RE: Syngenta Crop Protection, Inc
AI# 2367/ PER 20060029
LAD 053 783 445
Request for Variance from Secondary Containment Volume and Impermeable Coating
Requirements (LAC 33:V.1907.G) for Tanks 4609-F and 4604-F1

Re: Syngenta Crop Protection, Inc.-St. Gabriel Plant (Syngenta) Request For Variance
From Secondary Containment Volume and Impermeable Coating Requirements of
LAC 33:V.1907.E.1 for Permitted Hazardous Waste Tanks 4604-F1 and 4609-F in
Accordance with LAC 33:V.1907.G

Re: Syngenta Crop Protection, Inc.-St. Gabriel Plant (Syngenta) Responses to Hazardous
Waste Tank Certification NOD Letter of September 20, 2006
LAD053783445-RN-OP-1 AI #2367

7.0 SECONDARY CONTAINMENT

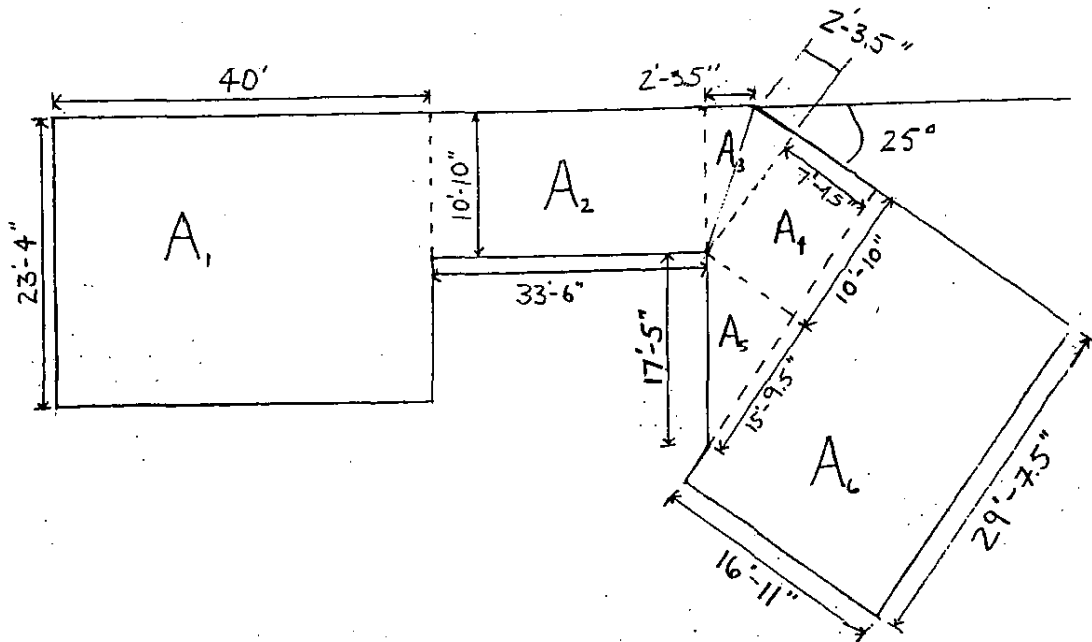
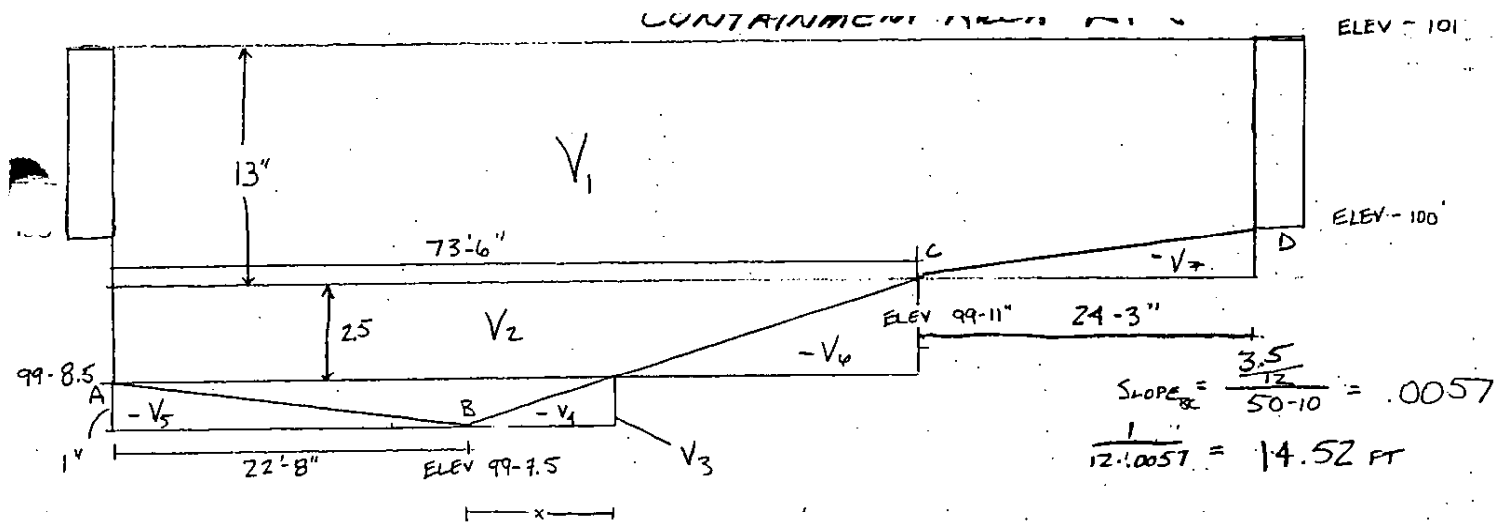
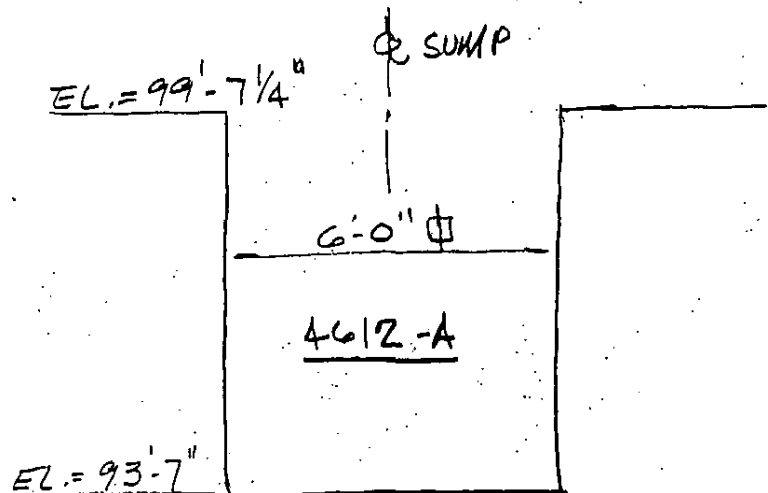
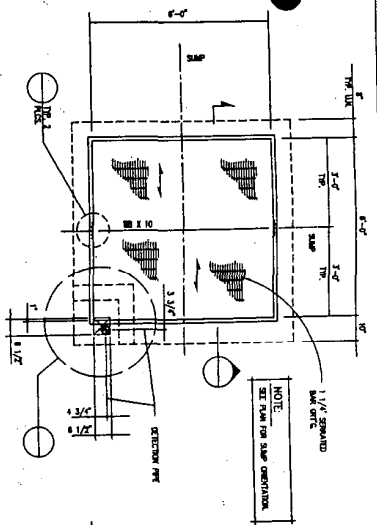
The secondary containment calculations provided must take into account the volume displaced by the concrete pads of both tanks in the containment area. As well, the diagram provided showing the layout of the containment area foundation is not readable. Facility must provide a clear diagram for verification of calculations.

The secondary containment calculations provided for tanks 4604-F1 & 4609-F must take into account the volume displaced by the concrete support pads of all tanks and equipment tanks in the containment area. The calculations provided do not take into consideration these concrete pads (as indicated on diagram 46-DC-071). Please update the calculations to show these displacements.

Revised secondary containment calculations are provided in Appendix B that include displacement of any objects in containment. The design and construction of the secondary containment system for this area is based on storage of the volume of the largest tank, 4402-F, plus a 25 year, 24 hour rainfall event, and take into account the volume displaced by the concrete pads of both tanks and the volume displaced by other items in the containment area. The calculation shows that the secondary containment meets the volume requirements of Section 1907 regulations.

There are two tanks inside the secondary containment for this area, Tank 4604-F1- the sludge hopper, and Tank 4609-F – the sludge silo. These tanks contain a dewatered filter cake, which has no free liquids. Failure of these tanks and spill of their contents onto the containment slab would result in a pile of filter cake with a natural angle of repose of 33°. The entire contents of the tank would not “pour” out of the vessel, which is what happens when a liquid storage vessel ruptures. Design of the containment system was performed using 12% of the volume of the largest tank in this area, which is Tank 4609-F – the sludge silo.

The secondary containment system for the sludge silo, 4609-F, consists of a reinforced concrete containment floor and 1'-0" high walls and a 6'-0" x 6'-0" x 6'-0" reinforced concrete containment sump with double walls and leak detection piping. All joints in the concrete are protected with water stop material and joint sealant.
